VALUE ENGINEERING CHANGE PROPOSAL
MISSOURI DEPARTMENT OF TRANSPORTATION

Contract ID 101217-503 **Job No.** J5S2179

MoDOT - RTE. 242 - MILLER/CAMDEN CO.
Conceptual VECP Proposal Submittal Data
Bloomsdale Excavating Co., Inc.
W. By-Pass Rte. MM

The contractor proposes to reconfigure the new Route MM stage 1 bypass in such a way as to eliminate the need for the stage 2 bypass.

Note: ***See attached x-section sheets with the revised fill quantity shaded in yellow.***

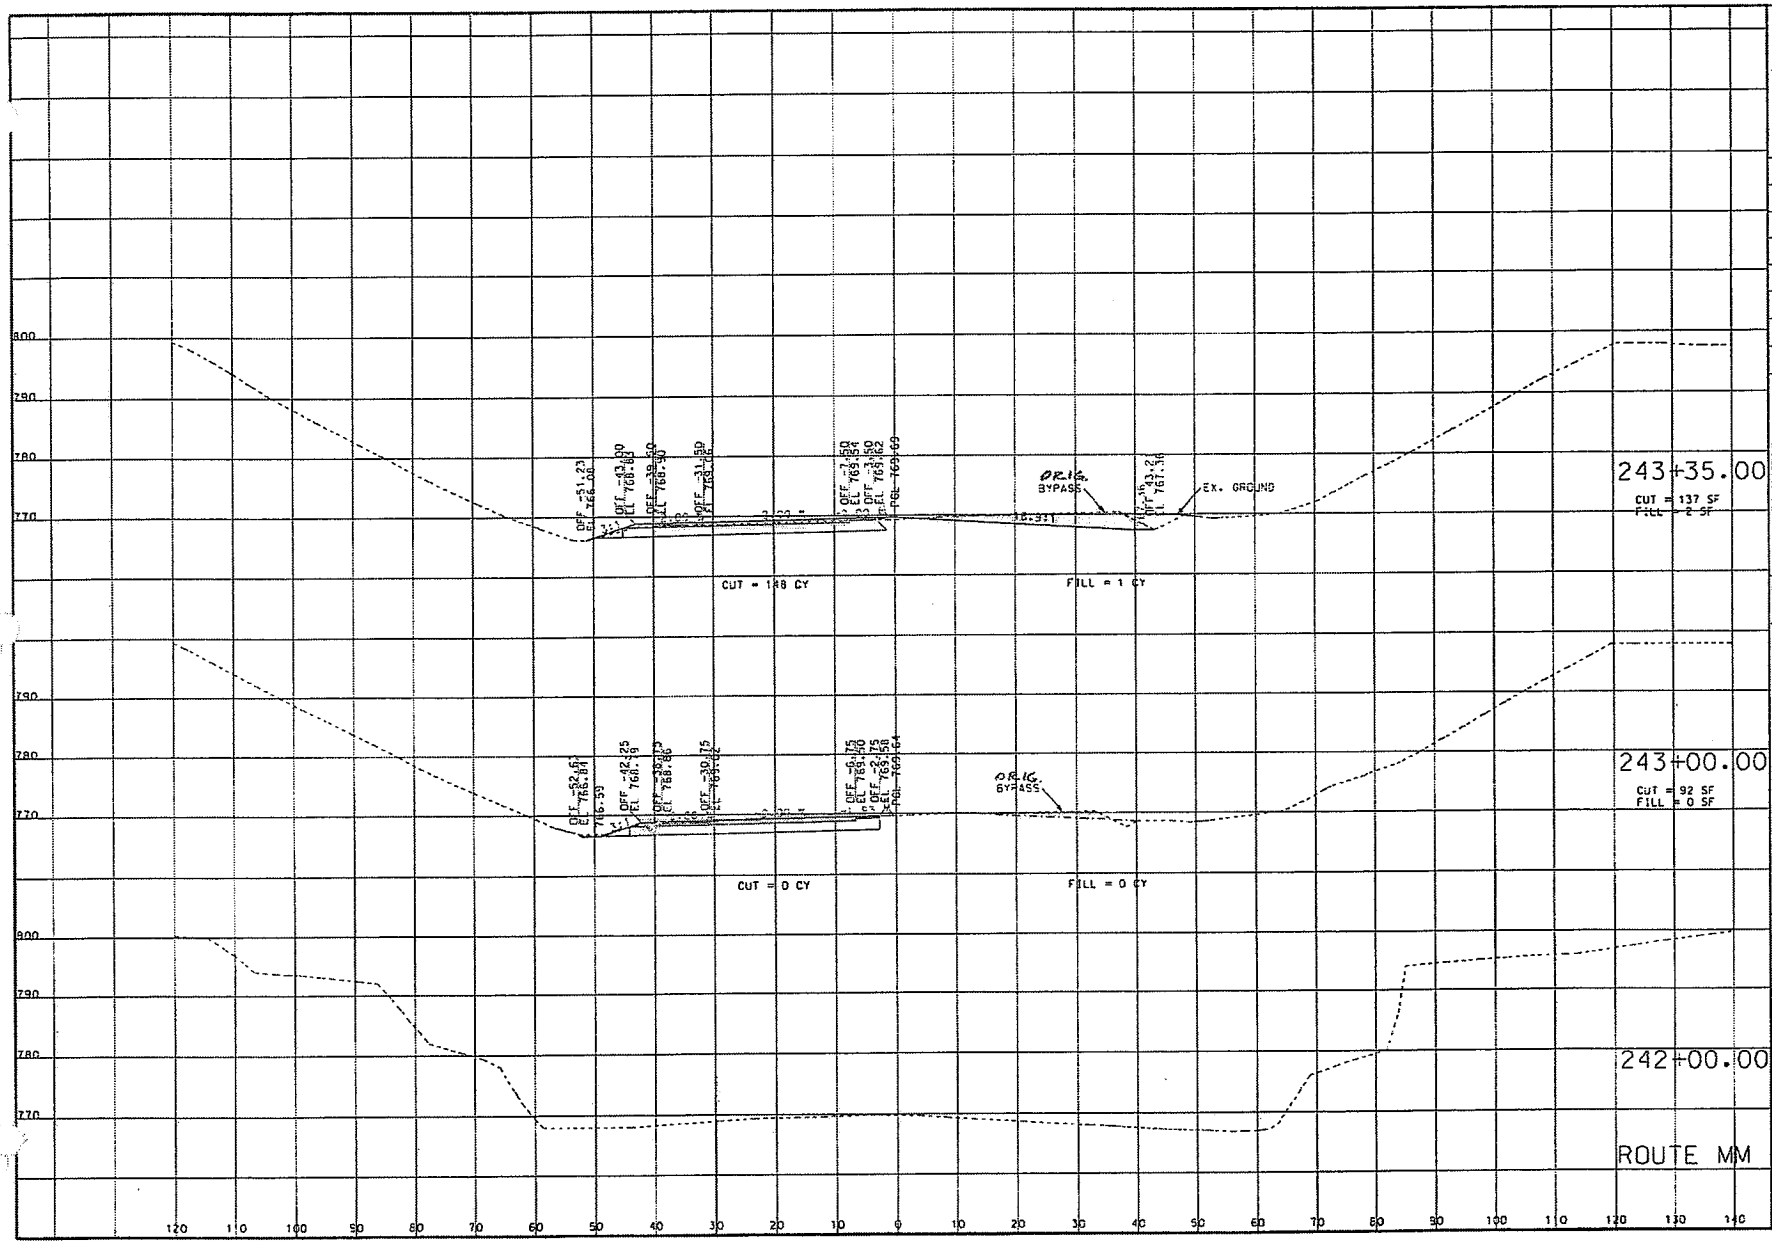
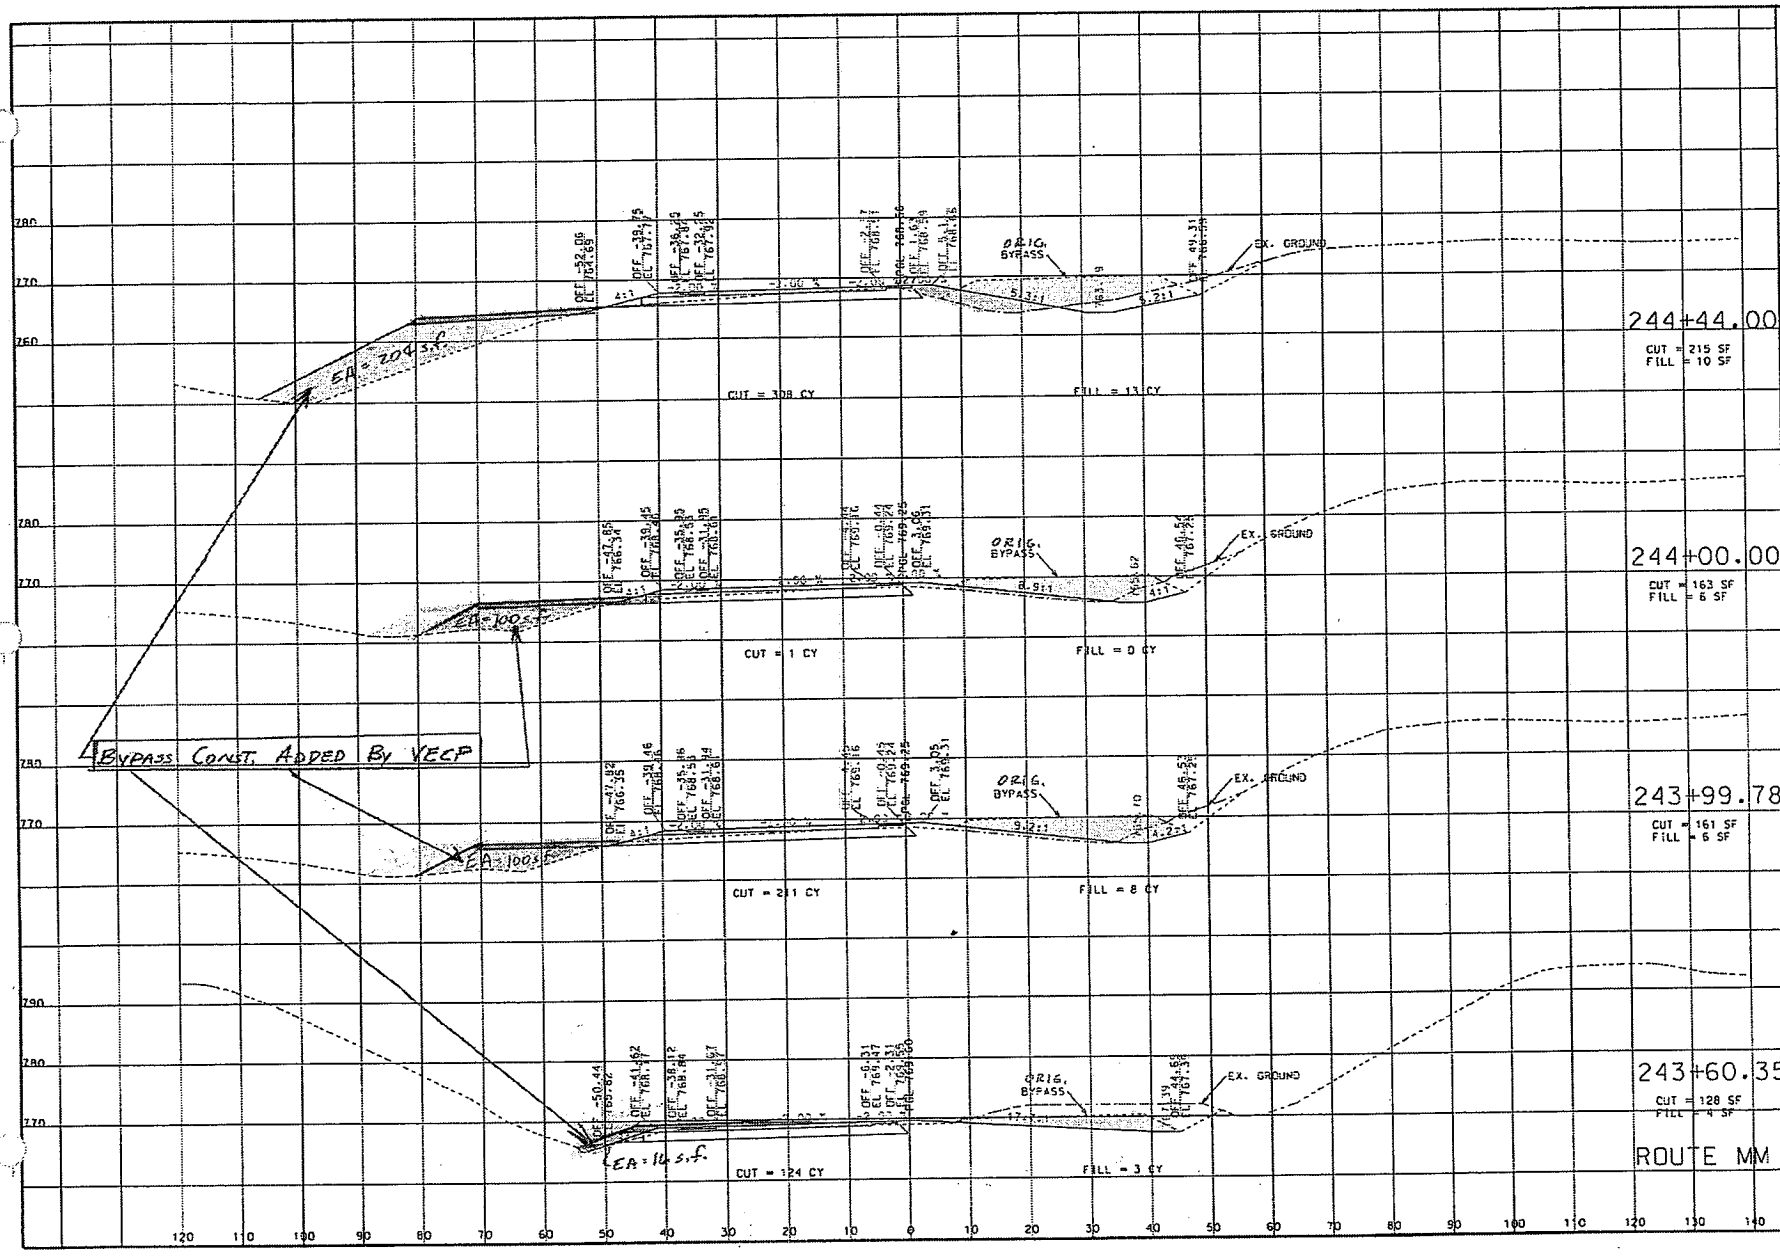
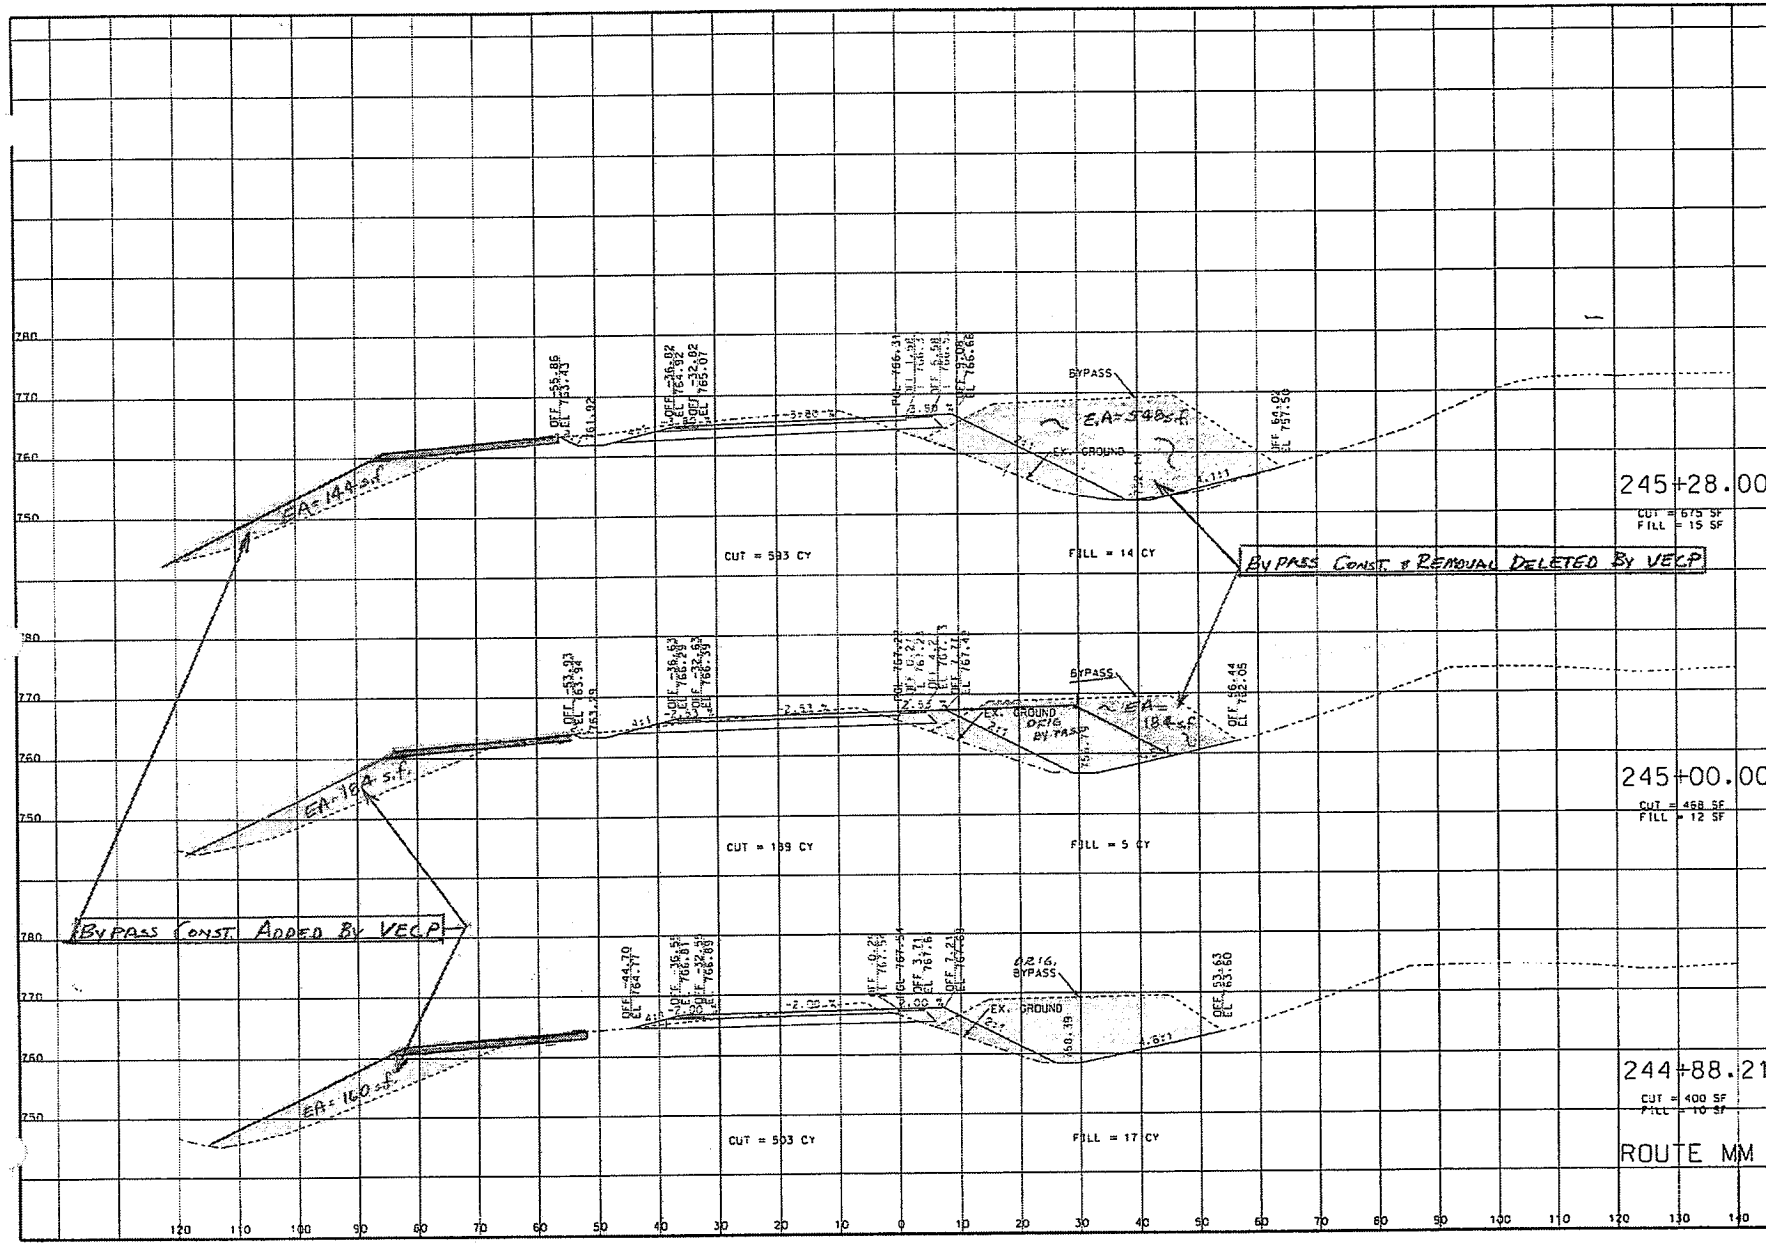
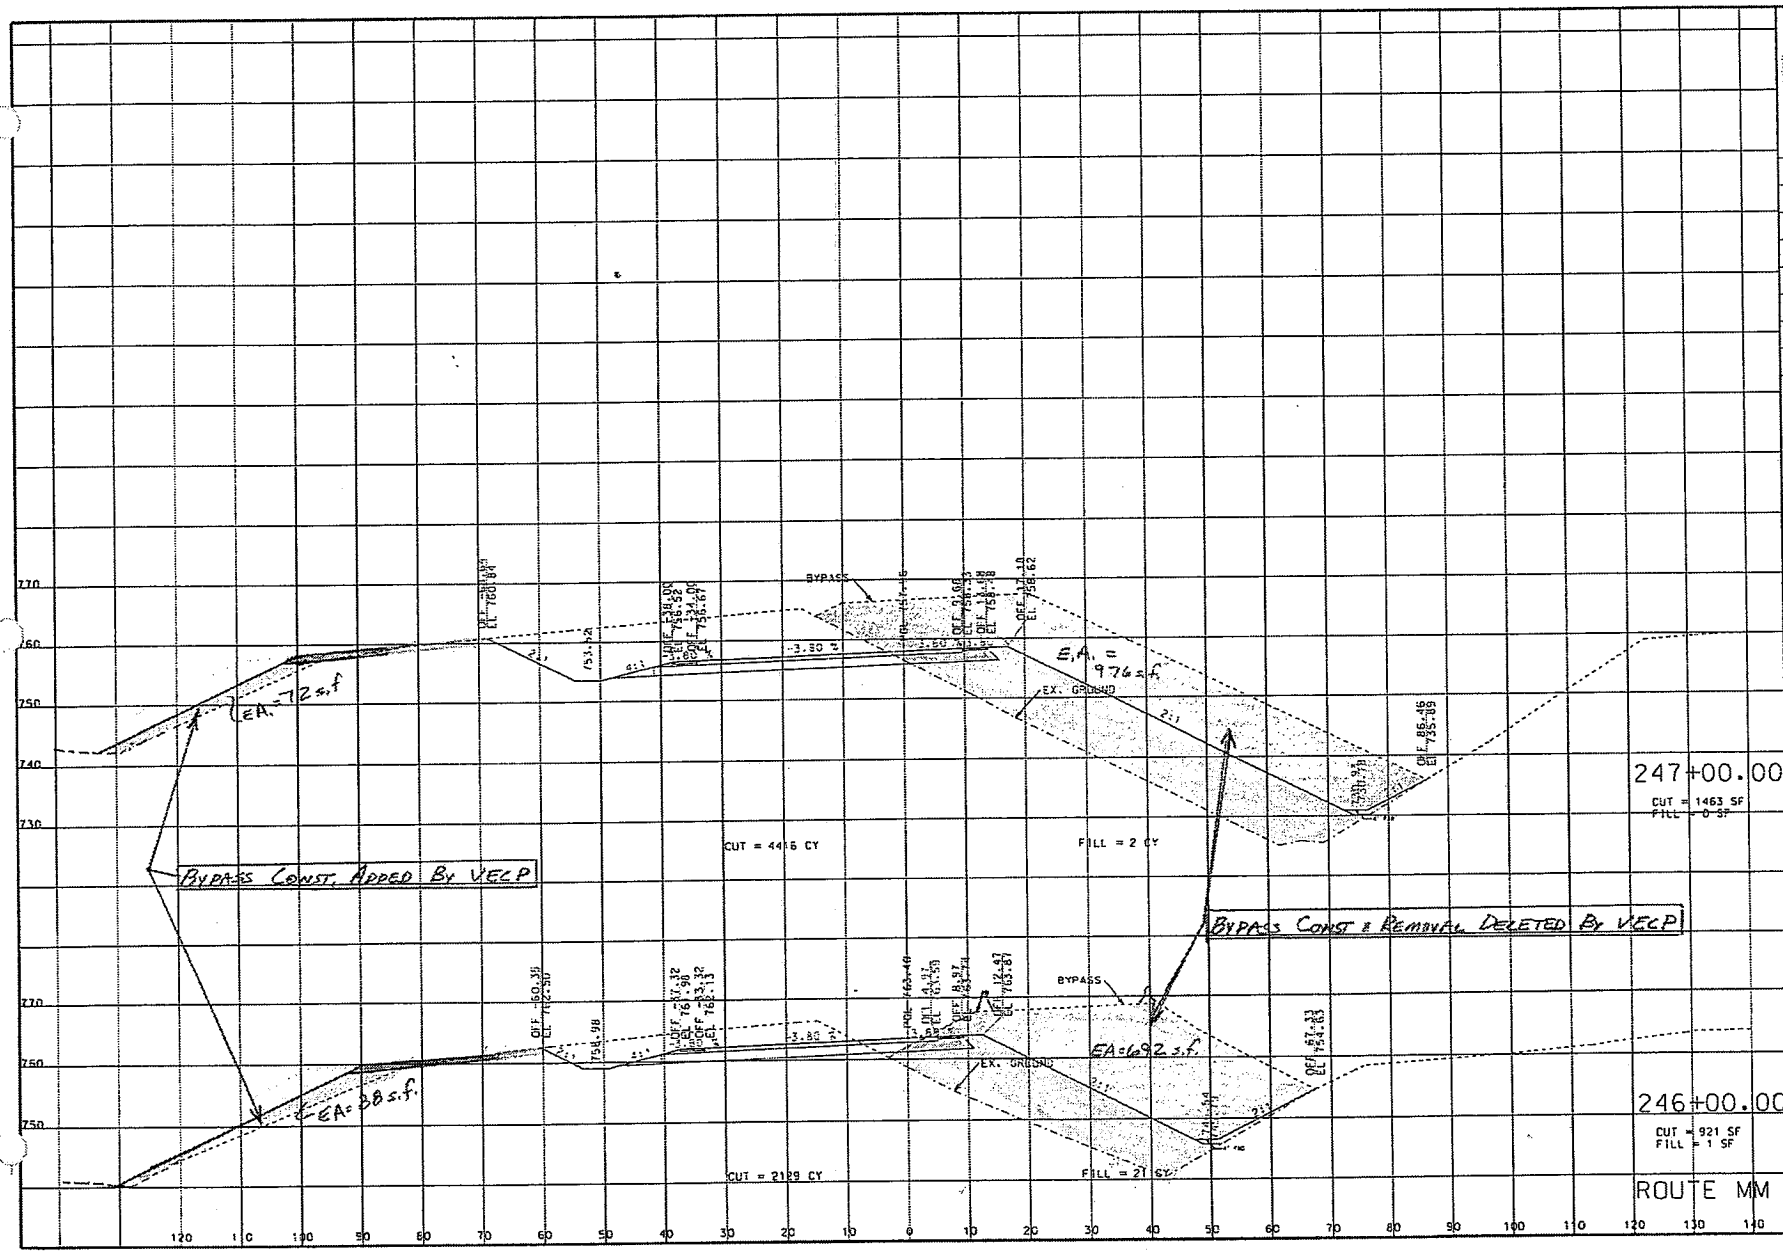
Note: ***See attached x-section sheets with deleted area shaded in red.***
